**GOVERNMENT HOSPITALS & HEALTH FACILITIES CORPORATION TERRITORIAL HOSPITAL
REDEVELOPMENT TEAM**

Amendment Eight (8)

IFB-001-THRT-T-023 (C) Renovation of the Charlotte Kimelman Cancer Institute
June 30, 2023

B4 GUARDRAIL SECTION DETAIL
SCALE: 1 1/2" = 1'-0"

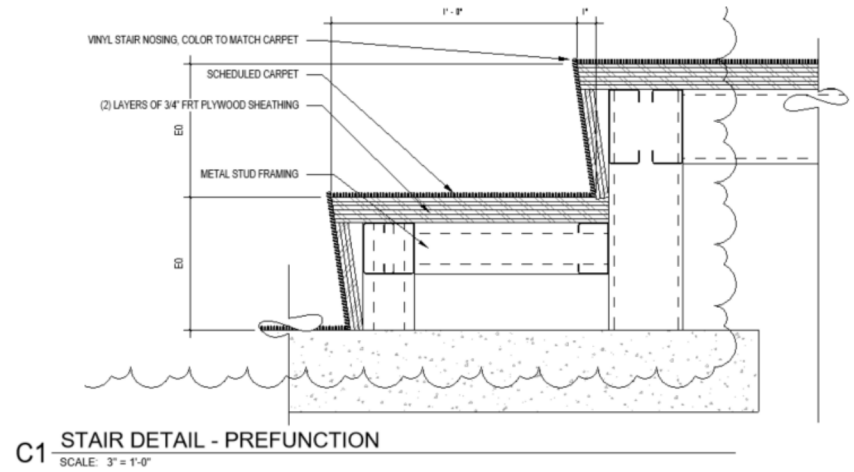
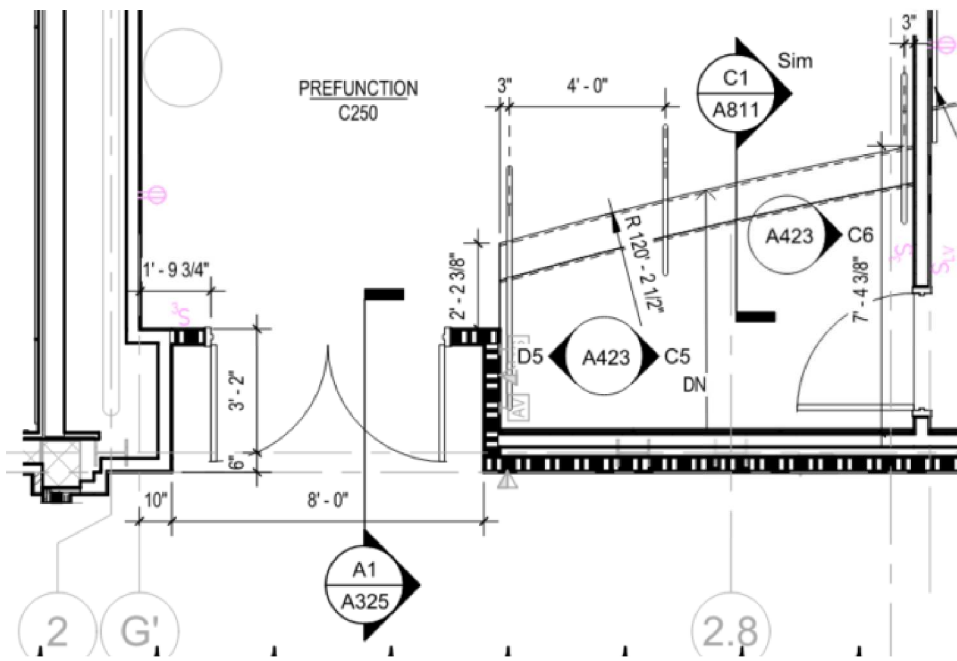
<p>Site Walls at Water Storage / Cistern Pad: a. Dwg C-301 calls for a railing on Retaining Wall No. 1 on the north wall only of the Water Storage / Cistern Pad. Dwg AS-201 shows a protective guard rail on the retaining walls at all three sides of the Water Storage / Cistern Pad. Please confirm if there are two separate railings along the north wall.</p>	<p>All railings are covered under architectural only. Civil drawings are only indicating that there is a railing.</p>
<p>Site Walls at Water Storage / Cistern Pad: b. We are unable to locate any details in the civil drawings for railings. If there are two different railings at the north wall, please provide details to include framing member sizes, spacing, and finishes for the railing shown on the civil drawings.</p>	<p>Refer to architectural drawings for railing information.</p>
<p>Site Walls at Water Storage / Cistern Pad: c. Detail A4, Dwg AS-201 states guardrail is to be 42” min above grade. Elevation E1, Dwg AS-201 states top of railing is to align with the adjacent perforated metal screen. We are unable to locate a height or elevation of the perforated panel joint. We assume railing height will be based on 42” above grade. Please confirm.</p>	<p>Refer to C1/A201 BUILDING ELEVATIONS for dimensions.</p>

<p>Site Walls at Water Storage / Cistern Pad: d. Elevations D1 – E1, Dwg AS-201 state the protective guardrails are to be metal square tube. Cross-section A4, Dwg AS-201 state the guard rail is to have round posts and infills. Please provide a cross-section of the railing to include post and infill dimensions and spacing.</p>	<p>See attached sketch CKCI-PB-SK01.</p>
<p>We are unable to locate details for the railings at stairs in Prefunction, C250. Please provide information to include railing size, post spacing, finish, etc.</p>	<p>See attached sketch CKCI-PB-SK02.</p>
<p>Amendment 6, RFI Response on Pg 3, regarding fireproofing can be interpreted that there is no new fireproofing on the project. Please clarify if new fireproofing is required on any of the new structural steel and/or metal decks.</p>	<p>The only fireproofing required is any repair of the existing spray proofing on the deck at the auditorium</p>

D5 PRE-FUNC - HANDRAIL 1
SCALE: 3/8" = 1'-0"

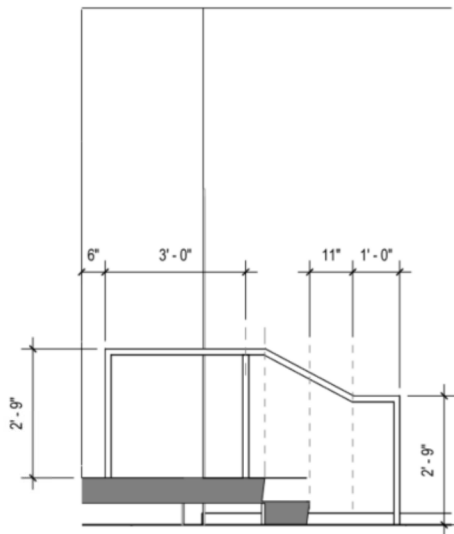
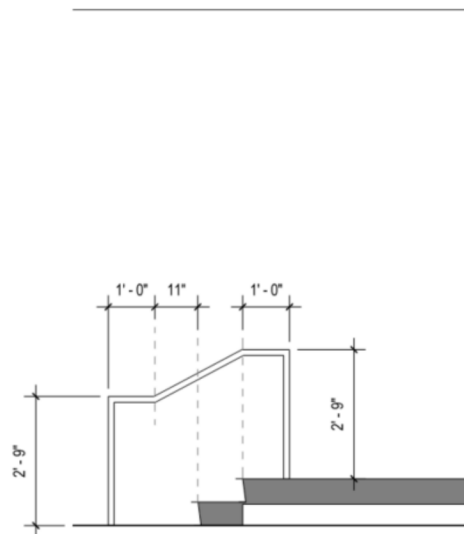
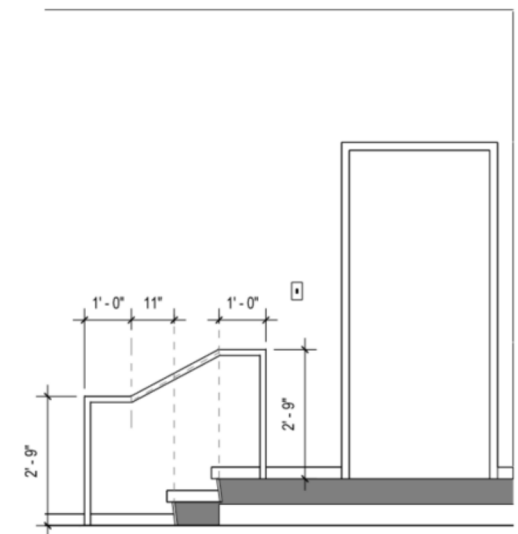
Handrails at Pre-Function to be 1 1/2" diameter aluminum pipe with brushed finish.
